LaserBase MF6530
LaserBase MF6540PL
LaserBase MF6550
LaserBase MF6560PL
LaserBase MF6580PL

MF6500-018
(F9-T01-M00-10037-01)

August 2007

Points to note when replacing the timing belt found in the reader assembly

P-1 READER ASSEMBLY

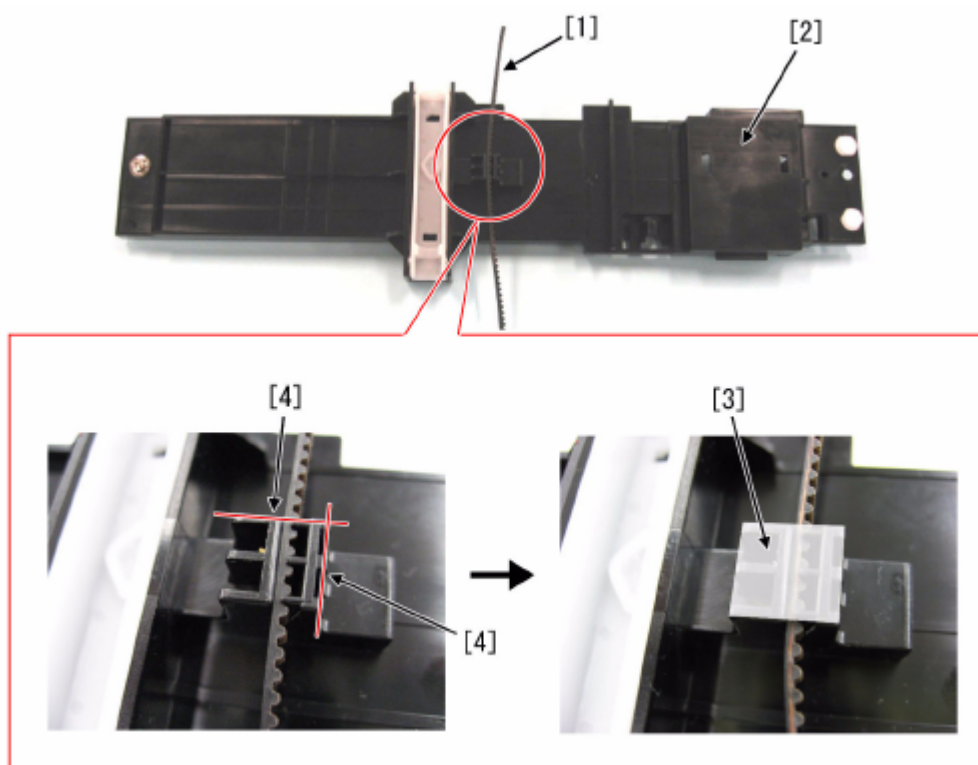
The timing belt [1] found in the reader assembly has been bonded to the CIS support [2] to prevent it from being detached due to vibrations during transportation. However, this method of fixation is discontinued, instead, the retaining sheet [3] is newly adopted to improve workability in replacing the belt.

When replacing the timing belt of a machine having a serial number earlier than the ones listed in “Affected Machines” below, attach the retaining sheet to the CIS support after replacement work (P-2).

When replacing the timing belt of a machine having one of the serial numbers listed in “Affected Machines” below, replace the retaining sheet by a new one at the same time. Be sure not to reuse the old retaining sheet because the adhesion of the two-sided tape is decreased once it is removed.
